PLANNING REPORT 22-17 for the TOWNSHIP OF GUELPH ERAMOSIA

CofA A04-22 – 105 Drenters CT

MEETING DATE: June 8th, 2022
TO: Chair and Members of the Committee of Adjustment
Township of Guelph Eramosa
FROM: Joanna Salsberg, Planner
County of Wellington
SUBJECT: **MINOR VARIANCE APPLICATION A04-22 (BASRA, BASRA, and SINGH)**
105 Drenters Court
Ward 4
SCHEDULES: **1 - Sketch provided by applicant**
2 - Site Visit Photo Showing Existing Posts

SCHEDULE 1: Sketch provided by the applicant

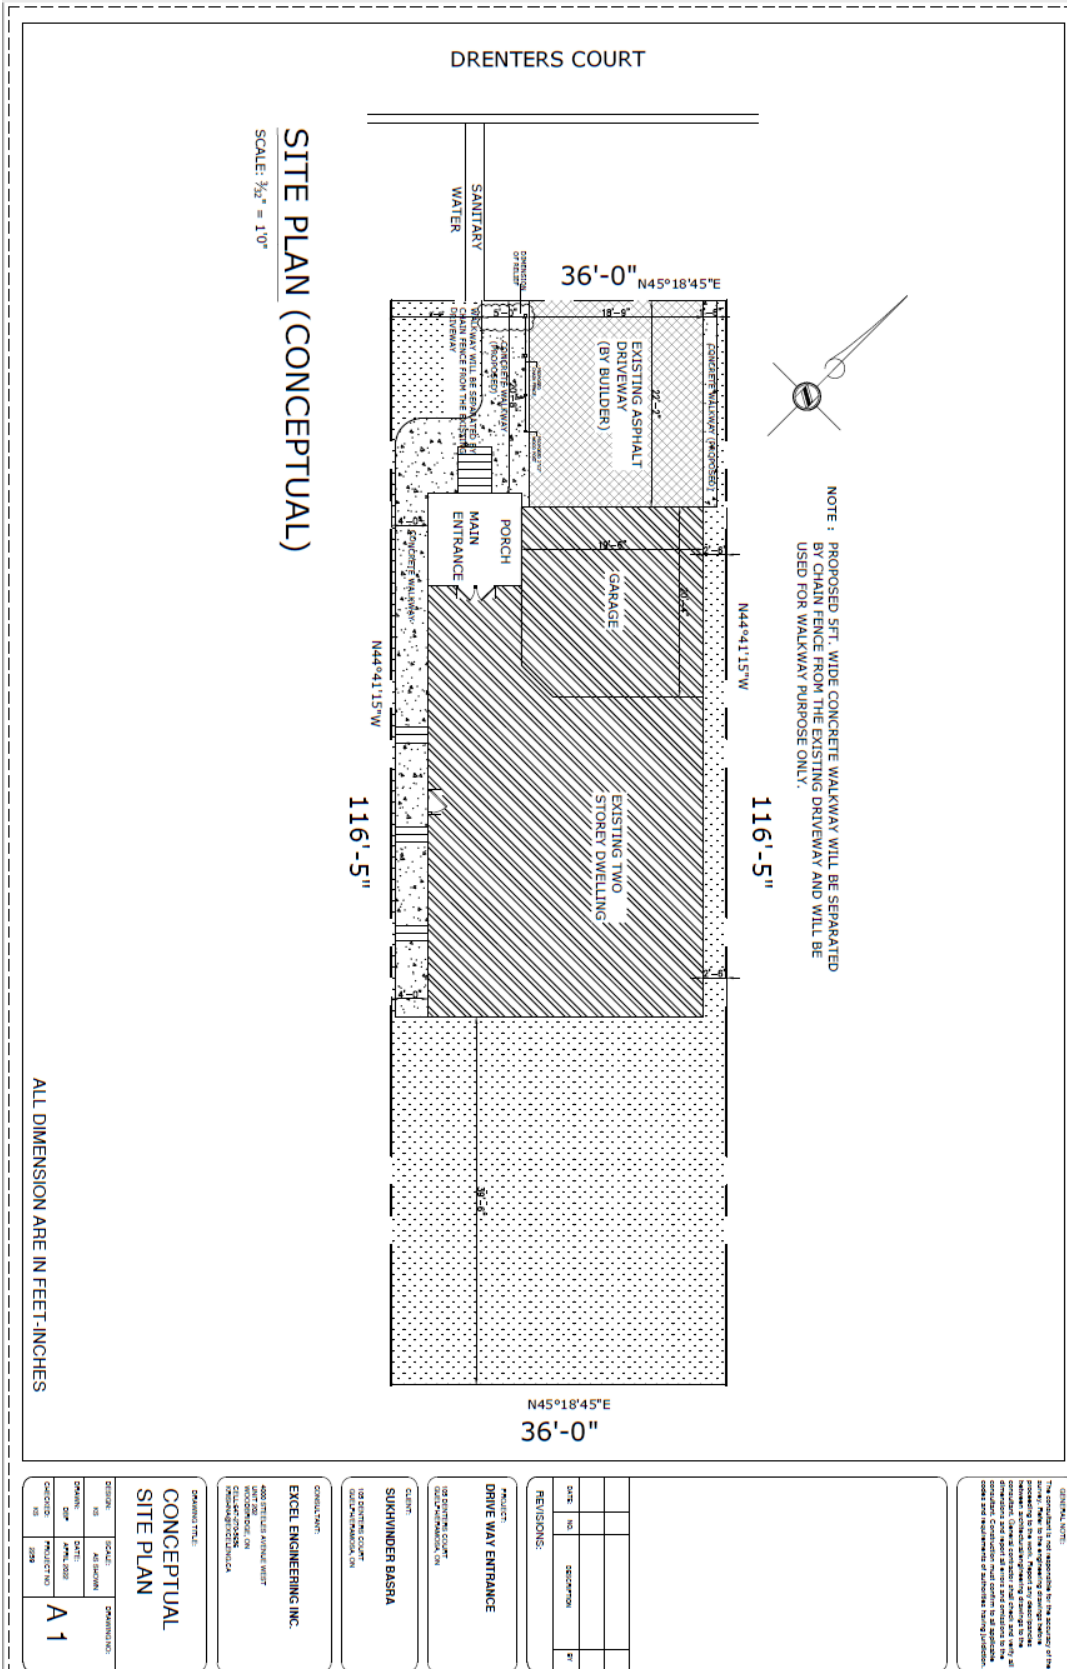
<p>parking space being located closer to the street line than required by the By-law. On the site plan, a parking space would be located 0.7 m from the property line, whereas 1.1 m is required. This is an existing condition of the driveway regardless of the proposed concrete walkways.</p>
<p>That the general intent and purpose of the Official Plan is maintained</p>	<ul style="list-style-type: none"> • The subject lands are designated as 'Residential' within the County of Wellington Official Plan and is located within the Urban Centre of Rockwood. • Residential uses are permitted within the Residential Designation.
<p>That the variance is desirable for the appropriate development and use of the land, building or structure</p>	<ul style="list-style-type: none"> • The increase in driveway width allows for a concrete walkway on both the left and right sides of the driveway. • A portion of the front yard continues to be landscaped. • The applicant has added posts blocking the use of the concrete walkway (right) for parking. A condition has been proposed to ensure the posts meet the requirements of the Fence By-law and the requirements of fencing within Daylight Triangle within the Zoning By-law. • Subject to appropriate grading and drainage, the additional width of the driveway would have no negative impact on neighbouring properties. • There are a variety of existing driveway widths on Drenters Court, with some properties also including concrete walkways. • A condition has been proposed to ensure that proper grading and drainage can be demonstrated to the satisfaction of the Township. • The Committee should consider comments from the Public Works and Building Departments regarding any concerns in regards to grading and drainage.

On the submitted site plan the applicant has indicated that the 1.5 m walkway (right) will be separated from the driveway by a chain-link fence and will only be used for walking purposes. The height of the fence has not been provided. On the site visit it was noted that the applicants have installed posts to prevent parking on the concrete walkway (right). **Attachment 2** contains an image of the posts as seen on the site visit.

As identified in the background section an additional relief was identified by staff after the issuance of the public notice. Section 5.1.10.2 of the By-law requires that parking areas cannot be closer than 1.1 m to any street line. The existing configuration of the garage and driveway result in one required parking space within the garage and one required space being on the driveway. This original configuration results in the parking area on the driveway being closer than 1.1 m from the street line of Drenters Court. This variance recognizes this existing deficiency on the parcel.

1. That the decorative sidewalk located at the left side of the driveway be removed to the satisfaction of the Township;
2. That the owner/applicant prepare and submit a grading and drainage plan to the satisfaction of the Township; and
3. That no parking be permitted on the decorative sidewalk to the right of the driveway and that the proposed fencing meets the requirements of By-law #52/2007 and the Sight Line Triangle requirements of the Zoning By-law to the satisfaction of the Township.

Overall, planning staff have concerns with the width of the driveway and on-site drainage. To address these concerns, conditions requiring the removal of one of the decorative sidewalks (to the left) is proposed as is a condition for a grading and drainage plan to the satisfaction of the Township. It is further recommended that a condition be imposed that parking not be permitted on sidewalk to the right of the driveway and that a barrier be approved to the satisfaction of the Township.
